MEMORANDUM

DATE:	February 05, 2021	RWDI REFERENCE #: 1904405
TO:	Anthony Witherdin	Director, Key Sites Assessments - DPIE
FROM:	Kevin Peddie	Email: kevin.peddie@rwdi.com
	Michael Pieterse	michael.pieterse@rwdi.com
RE:	Overshadowing – Southern Precinct Waterloo Metro Quarter

It is understood that after submission of the planning documents for the Waterloo Metro Quarter Development, commentary has been provided on the submission. The comments received are noted below, with commentary in response discussed in this memo. This document is as an addendum to the submitted Appendix MM – Overshadow report for the entire precinct.

Image 2: Nearby existing Residential Apartment Buildings

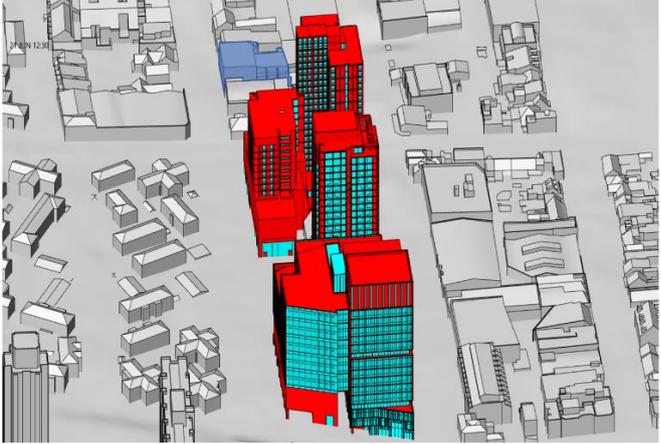
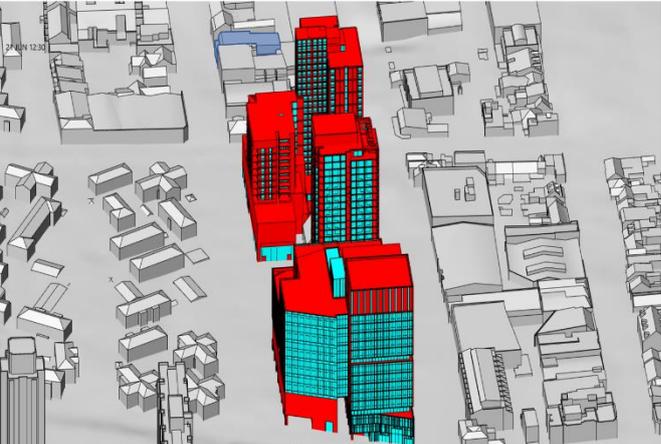
Further to this, a letter of objection is noted to also have been received from the Owner's Corporation of Velocity, located at 180 Cope Street, which noted the following regarding solar access / overshadowing concerns.

Six (6) of the apartments contained within 180 Cope Street, Waterloo have direct northerly aspect and access to sunlight through windows or doors opening onto their private balconies. (which is the only source of natural light into these apartments living areas). As depicted on the shadow diagrams prepared and submitted by the project planners, the impact of the proposed development will be detrimental as these owners will lose significant solar access.

For each of the 11 studied buildings, given the separation distance between the Waterloo Metro Quarter precinct and these buildings, sufficient level of daylight is expected to be maintained which is a separate metric to direct solar access.
